# SERVICE INSTRUCTIONS

No. 0042-031, Rev. II  
ATA Code 53-40  
Recurring Inspection

**SUBJECT:** FUSELAGE - INSPECTION OF FORWARD WING ATTACH POINT

**SYNOPSIS OF CHANGE:** Service Instructions rewritten in current format. Deleted requirement to remove the attach bolt for inspection. MATERIAL and ACCOMPLISHMENT INSTRUCTIONS revised to use improved current configuration parts. Closed serial effectivity of these Service Instructions to exclude those airplanes which were manufactured with improved parts. Option is given to retrofit affected airplanes with improved parts.

Figure 1.

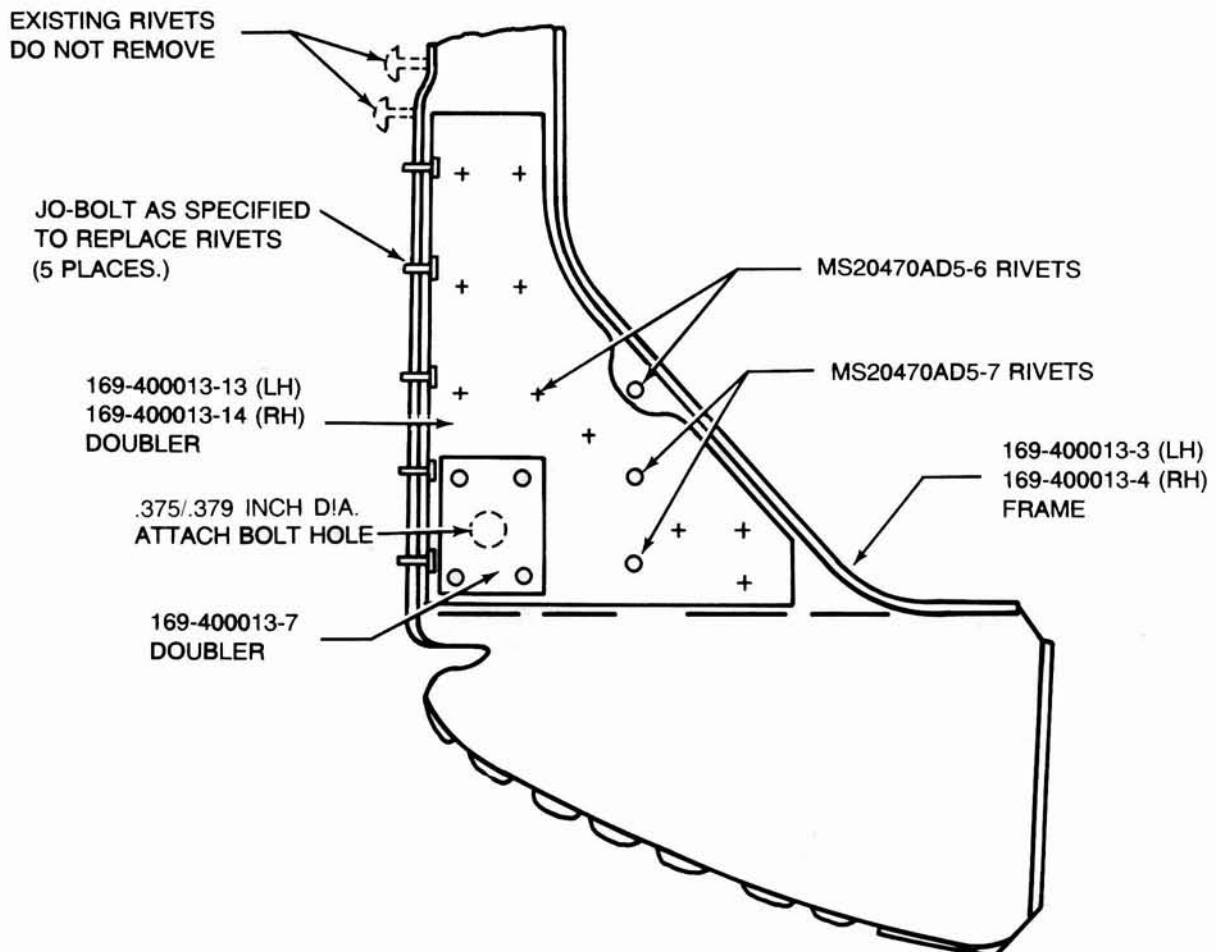
3. Drill out the three rivets through the bracket and frame, and the five rivets through the outboard flange of the bracket and the fuselage skin (See Figures 1 and 2), and discard the bracket.
